Kapalua Schematic

BDQ11/LA1601 Schematic with Capture CIS and Function field
uFCPGA Banias
02-12-2003
REV: 0.5

DELL CONFIDENTIAL/PROPRIETARY		
Compal Electronics, Inc.		
Title		
Cover Sheet		
Size	Document Number	Rev
	BDQ11/LA-1601	0.5
Date:	星期三, 二月 12, 2003	Sheet 1 of 56

Title CPU Bypass		
Size C	Document Number 8DQ111A-1601	Rev 0.5
Date 星期日, 三月 06, 2003	Sheet 9	of 56

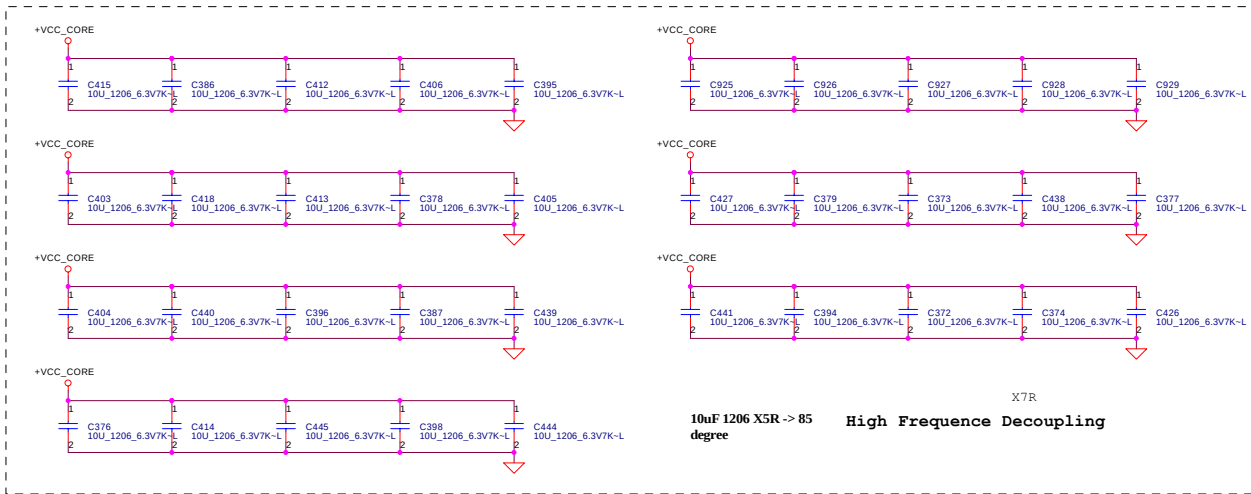
Need change 2V parts

10/29

CPU Bulk

11/29

Depop for Cost down

01/03
Item 91

60	9	Vcore Bypass CAP.	11/29/2002	Compal	Vcore by pass capacitors adjust for cost	Add C941~C944 (220UF_2V) Depop C671~C675, C678 (220UF_2V)	X02
61	40	Power Control	11/29/2002	Compal	package change for increase voltage tolerance	C680 changed package from 0402 to 0603	X02
62	20	ICH4	12/02/2002	Compal	Depop dummy part	Depop R529 (10K_0402)	X02
63	25	Dog House	12/04/2002	Compal	package change for component easy to buy	C940 changed package from 0805 to 0603	X02
64	30	Smart Card	12/11/2002	DELL	Need to implement 5 Smart Card changes.	Add R12, R26, C184 , C189 , Change C171 value from 390P to 470P	X02
65	27	BCM5705 By Pass	12/11/2002	DELL	Need to change package from 0805(4.7UF) to 1206(10UF) for cost	C339, C346, C352, C355, C393, C662, C368, C342	X02
66	All Pages	Page Symbol	12/13/2002	DELL	Put "DELL CONFIDENTIAL/PROPRIETARY" on Schematics	DELL CONFIDENTIAL/PROPRIETARY	X02
67	20	ICH4	12/13/2002	Compal	Delay Thermtrip to ICH4 so Intruder have time to get latch	Add C46 (0.1UF_0402)	X02

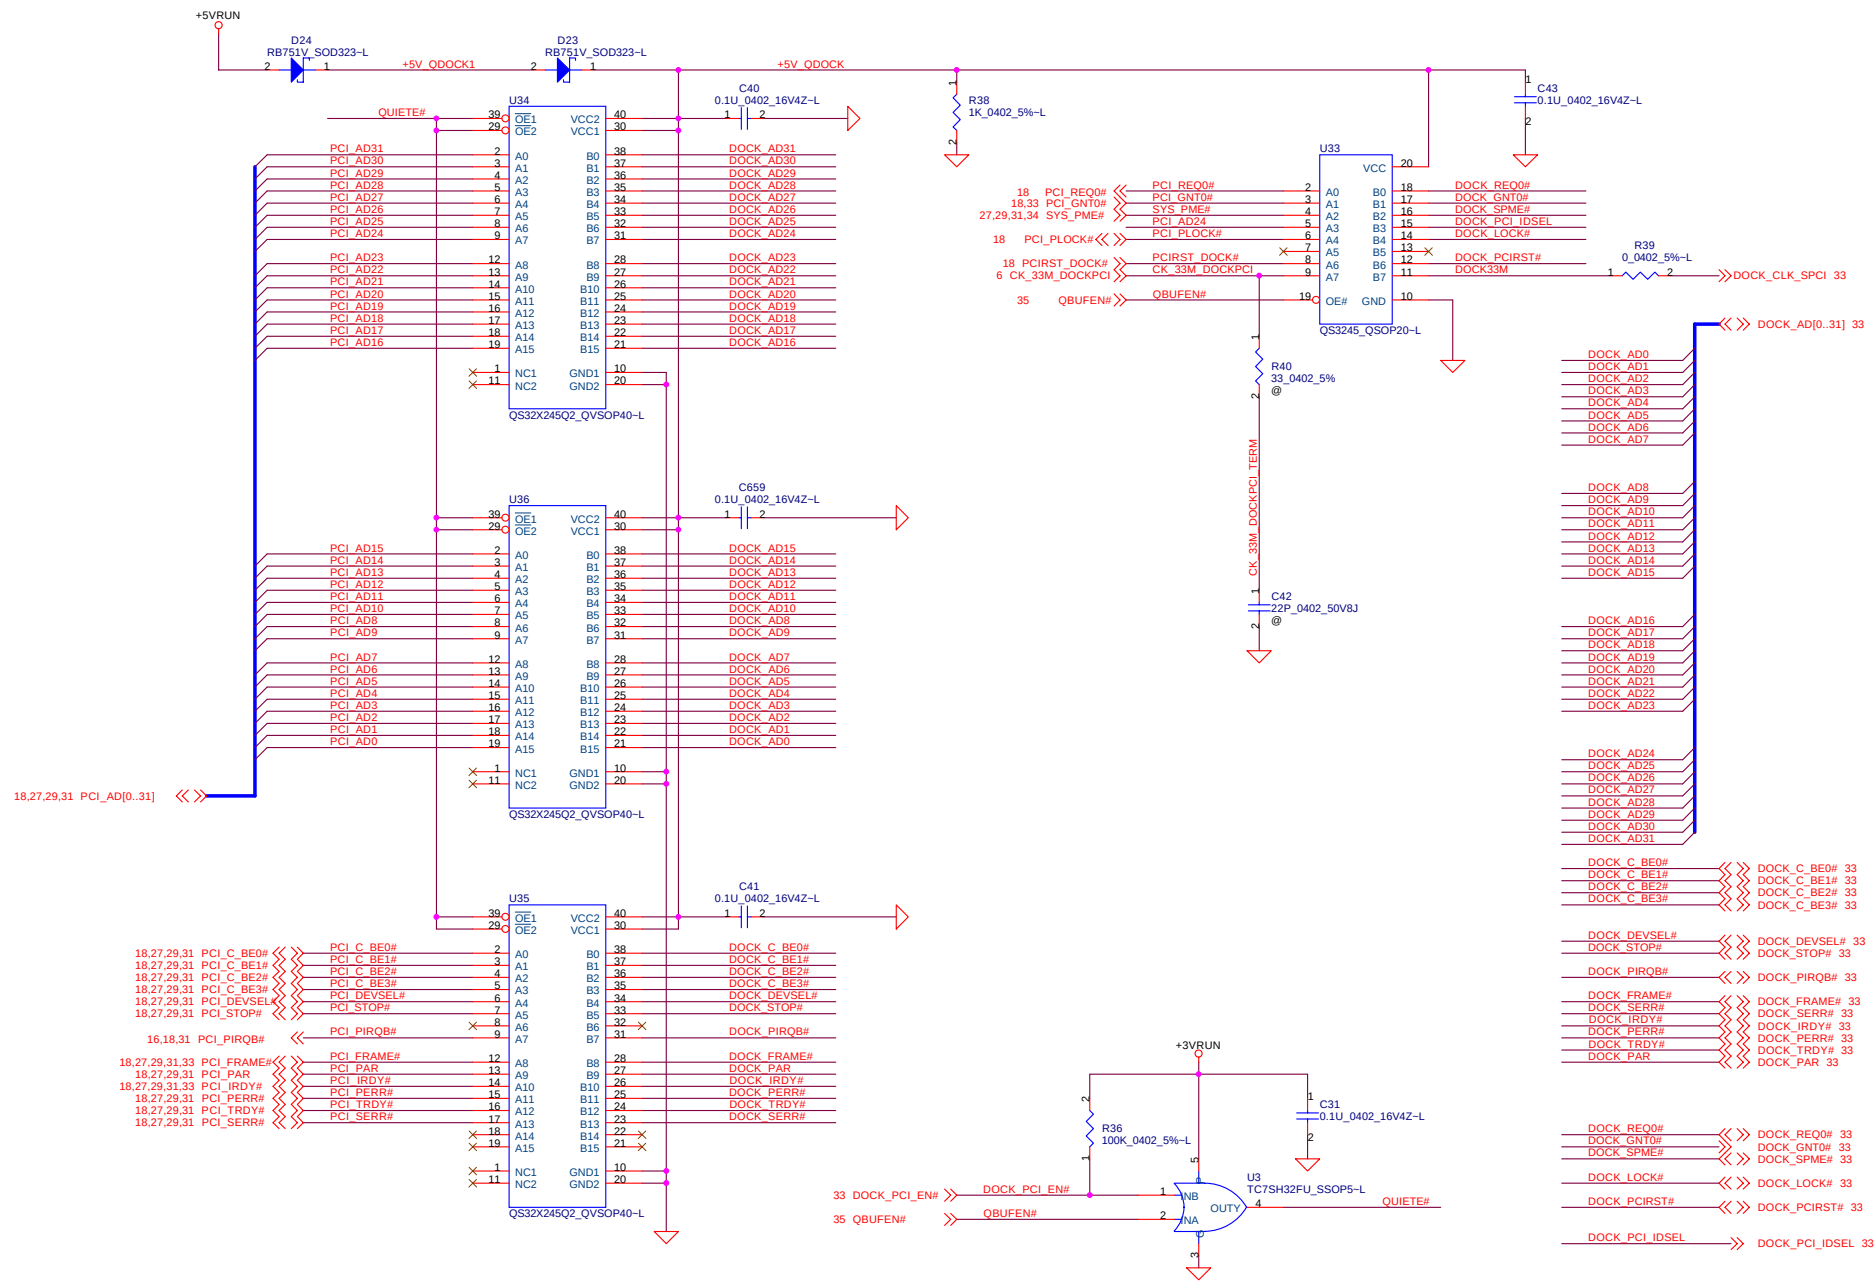
8/19 Changed netname from 4401_CLOCKRUN to 7705M_CLOCKRUN by Dell's required
8/23 Changed netname from 4401_CLOCKRUN to 5705M_CLOCKRUN by Dell's required
DELL CONFIDENTIAL/PROPRIETARY

Title	PAD and Standoff		
Size	Document Number	BDQ11/LA-1601	Rev 0.5
Date	星期二, 二月 06, 2003	Sheet 41 of 56

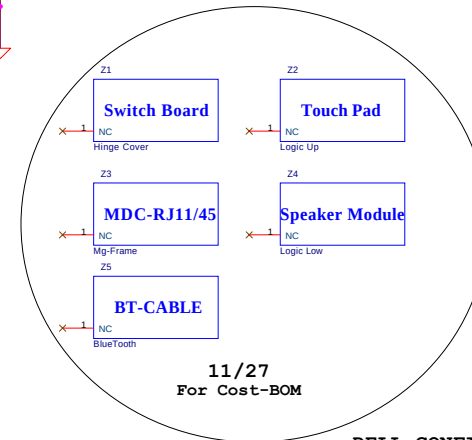
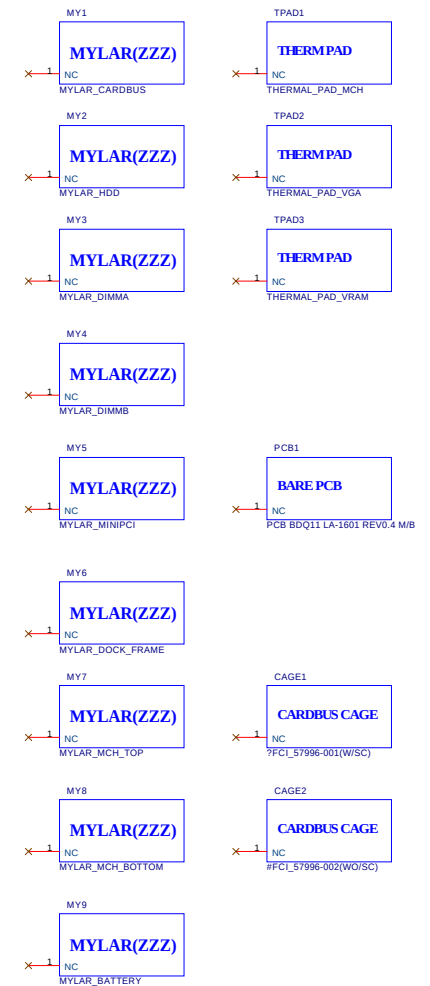
11/27
For Cost-BOM

Item	Page#	Title	Date	Request Owner	Issue Description	Solution Description	Rev.
54	41	PAD & ME Parts	10/30/2002	Compal	Need to BLOW OUT 2.5mm Radius from Vias used to transition Tip and Ring from InnerLayer 4 to Bottom layer	Deleted H43 to meet 2.5mm Radius gap	X01
55	28	Magnetic & RJ45	10/30/2002	DELL	LAN Analog Switch (PI3L301BA) serial Resistors change type to Inductors	R776~R783 changed value from 0Ω to 15nH Inductor (TDK MLK1005S15NJ)	X01
56	27	POP option to 5705	11/08/2002	Compal	change the POP option from 5702 to 5705	Depop L66, C344, C324 Pop R217, R549	X01
57	38	Thermal shut down to 6509	11/08/2002	DELL	change the thermal shut down solution from discrete to MAX	Add U6, R30, R24 Depop U2, C29, R28, R20~R23, C27, R53, C65	X01
58	27	LOM	11/27/2002	Compal	Depop dummy parts	Depop R388 (10K_0402) and C390 (0.01U_0402)	X02
59	41	PAD, ME, SPARE PARTS	11/27/2002	Compal	Add Cost-BOM parts	Add Z1(Switch-FPC), Z2(Touch_pad-FPC), Z3(MDC-Cable), Z4(Spk-mODULE), Z5(BT_Cable).	X02

Title				1.25V/2.5V			
Size	Document Number						Rev
	BDQ11/LA-1601						0.5
Date:	星期四, 二月 06, 2003			Sheet	46	of	56

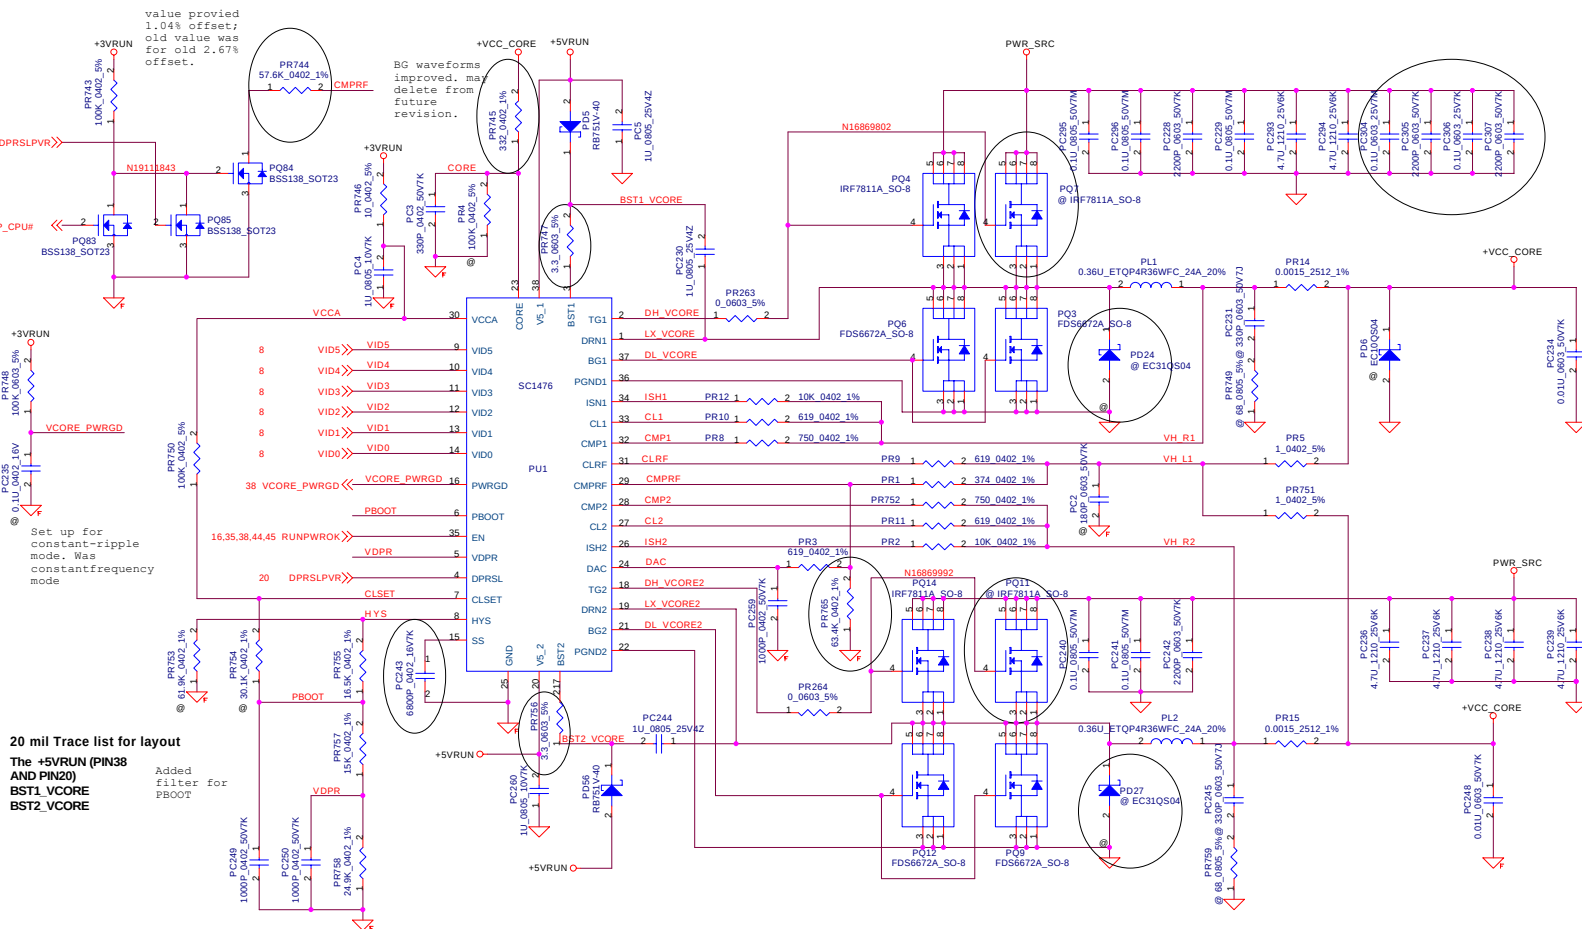
```
09/26 By |
Dell's   |
Request  |
- - - - -
```

23	40	Power Control	9/26/2002	Dell	We need a Soft Start feature	Add C680 to 0.1uF	X01
24	20	ICH4-M	9/26/2002	Dell	Change Board Rev resistor to X01	Depopp R287, and Pop R286	X01
25	45	1.5V / 1.05V	9/26/2002	Dell	Add 0 ohm resistor at PU18 pin 15 and pin 16	Add PR769 and PR770 to 0Ω	X01
26	46	1.25V / 2.5V	9/26/2002	Dell	Add a 0 Ohm resistor at PU11 pin 15	Add PR771 to 0Ω	X01
